# Service Bulletin

**Subject:** Delayed Engagement After Sitting With Engine Off - Torque Converter Fluid Drain Back

- A. Old stator support asm
- B. New stator support asm

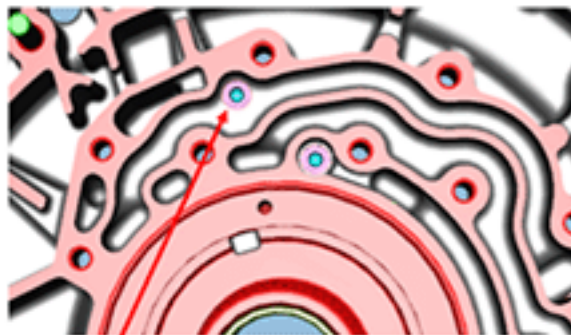
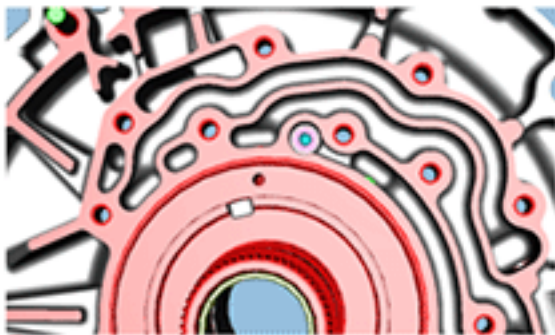
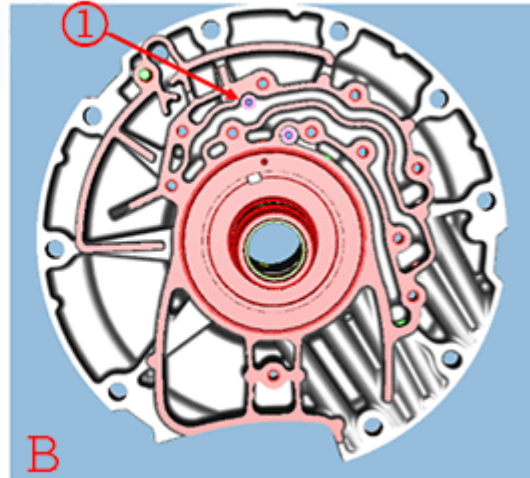
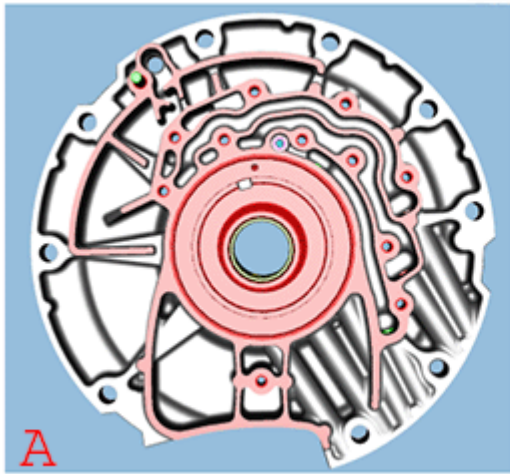
**Note:** The new stator shaft support assembly has a second check ball (1) added (see illustrations).

Install a new stator shaft support assembly that includes an additional check ball. Follow the instructions below to replace the stator shaft support assembly.

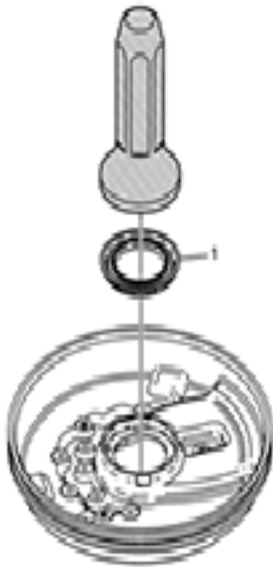
**Note:** The casting void has been eliminated from the underside of the cover for the 8L90 only (see illustration). The 8L45 is not required.
